Secure 1000 Radiation Emission Measurement

FORM R-0646-1 (Single Pose)

Re: Rapiscan AIT System Radiation Survey Reporting

**R-0646-1 Addendum
(Documentation Errors)**

1. In Beam Dose Measurement: Survey Table. 1

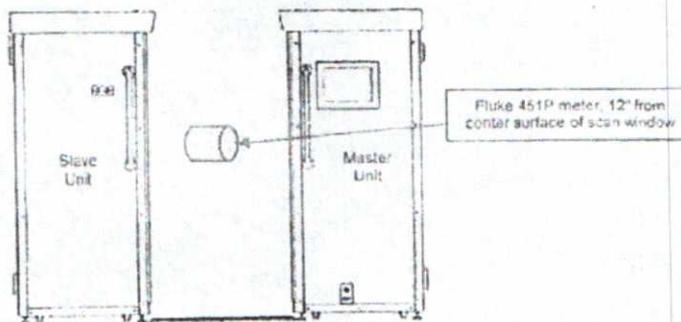
1. No value indicated for background radiation. Typical values range from 7uRem/hr to 13uRem/hr at sea level. Note: Absence of value has no adverse impact on calculations.
2. TABLE 1: Incorrect presentation of data in Column 3 for Measured Exposure. Indicated values are 42uR and 45uR. Corrected values are 4.2uR and 4.5uR.
3. TABLE 1: Incorrect presentation of data in Column 6 for Effective Dose. Indicated values are 24 uRem and 25 uRem. Corrected values are 2.4 uRem and 2.5 uRem.
4. Technician did not initial pass or fail check box.
5. Technician did not print his name.

The service technician should attend refresher training.

The corrected data indicates this system was operating within expected parameters. No re-survey is required for this system.
